## RESIDENTIAL COMMUNITY ZONING PLAN

Prepared for Oak Half Companies, LLC 5256 Peachtree Road, Suite M

APPLICANT	Cak Hall Companies, LLC	PETITION NO:	Z-56
	EMAIL:		09-07-17
REPRESEN'	TATIVE: Parks F. Huff	HEARING DATE (BOC):	09-19-17
	770) 422-7016 EMAIL: phuff@slhb-law.com		R-30
TITLEHOL	DER: Audrey Mae Wigley, By Gloria Wigley as		
Administrator	for the Estate of Audrey Wigley	PROPOSED ZONING:	R-15
PROPERTY	LOCATION: East and west sides of Wigley Road,		
north of Sumi	mitop Road	PROPOSED USE: Single-fa	amily Subdivisi
ACCESS TO	PROPERTY: Wigley Road	SIZE OF TRACT:	55.26 acres

### **Z-56 2017-GIS**

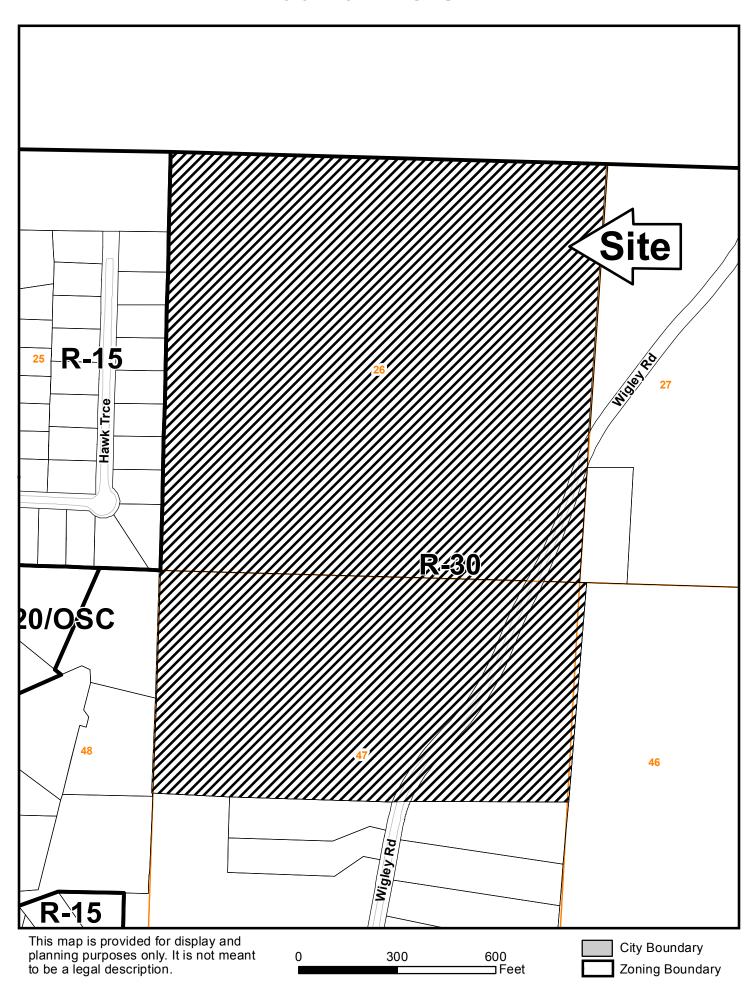
Applicant is requesting the R-15 zoning district for the purpose of developing an 85-lot single-family subdivision. The proposed houses will range in size from 3,200 to 4,000 square feet and will have traditional architecture with brick, stone and cementitious siding. There will be a pool, clubhouse and 10.6 acres of open space.

The proposed site plan will require the following contemporaneous variances:

- 1. Waive the front setback on all lots from the required 35 feet to 25 feet; and
- 2. Waive the public road frontage on cul-de-sac lots from 50 feet to 38 feet.

- 1. This site is located on the northern portion of Wigley Road. The site lies on a steep ridgeline and drains in three directions. The majority of the site (40%) drains to the south roughly parallel to Wigley Road. Approximately 35% of the site drains to the northeast along Wigley Road into Cherokee County. The remaining 25% of the site drains to the west into and through the adjacent Falcon Crest Subdivision. The site is predominately wooded with steep slopes ranging from 12 to 40%. The site layout needs to be sensitive to the steep topography. A preliminary rough grading plan should be provided to verify feasibility of the proposed layout.

- 2. Stormwater management for the site will be provided by multiple onsite detention ponds. The pond locations may need to be adjusted to limit grading required and to adequately control runoff from the development.

- 3. As indicated in the Downstream Conditions comments above, there is an existing lake located approximately 300 feet downstream. A pre- and post-development sediment study will be required to document any sediment impacts to this lake. Elevated onsite erosion control measures will be required due to the steepness of the site.

- 4. A downstream headwater pool analysis will be required for the existing receiving culvert in Falcon Crest S/D to verify no adverse impact. The basement at 2254 Hawk Trace is located significantly below the low point of the road.

Wigley Drive is classified as a local and according to the available information the existing right-of-way does not meet the minimum requirements for this classification.

Recommend curb and gutter along both sides and sidewalk along one side of proposed development roadway.

The existing Wigley Road right-of-way will need to be abandoned prior to Land Disturbance Permit.

Recommend a traffic study. The traffic study should include existing and base year (full build out year) Build and No Build analysis; and horizon year (base year + 10 years) Build and No Build analysis. Study assumptions (such as study intersections, trip distribution and annual growth rate) should be agreed to by Cobb DOT before completing the study.

- A. It is Staff's opinion that the applicant's rezoning proposal may not permit a use that is suitable in view of the use and development of adjacent and nearby properties. Almost all of the properties on this part of Wigley Road are zoned R-30 (only a portion of this part of Wigley Road is not zoned R-30.

- B. It is Staff's opinion that the applicant's rezoning proposal may have an adverse effect on the usability of adjacent or nearby property. The property is severely impacted by steep slopes and staff is concerned about erosion issues downstream and downslope. Other developments, zonings and densities in the area include: Jefferson Township Phase Five (zoned PD at approximately 0.32 units per acre); The Summit at Sweat Mountain (zoned R-30 at 0.72 units per acre); Bluffs at Jamerson (zoned R-20 at approximately 1.60 units per acre overall for Phases 1 and 2); Hampton Ridge Unit IV (zoned R-15 at 1.65 units per acre); and Falcon Crest Subdivision Unit III (zoned R-15 at approximately 2.50 units per acre).

- C. It is Staff's opinion that the applicant's rezoning proposal may result in a use which would cause an excessive or burdensome use of existing streets, transportation facilities, utilities, or schools. This opinion can be supported by the departmental comments contained in this analysis.

- D. It is Staff's opinion that the applicant's rezoning proposal is in conformity with the policy and intent of the *Cobb County Comprehensive Plan*, which delineates this property as being within the Very Low Density Residential (VLDR) land use category, for densities ranging from 0-2 units per acre. The applicant's proposed density is within the VLDR range at 1.54 units per acre. It should be noted that the current zoning district is also in conformity with the *Cobb County Comprehensive Plan*.

- E. It is Staff's opinion that there are existing and changing conditions affecting the use and development of the property which give supporting grounds for denying the applicant's rezoning proposal. Just about all of this portion of Wigley Road is zoned and developed as R-30. The steep slopes would lend themselves better to development if developed as R-30 because the lots would be bigger and there would be less grading. Staff is aware that other developments on nearby properties have caused drainage and sedimentation problems due to putting smaller lots on steep slopes. R-30 zoning would fit the character of area better than R-15 for this section of Wigley Road.

Based on the above analysis, Staff recommends DENIAL.
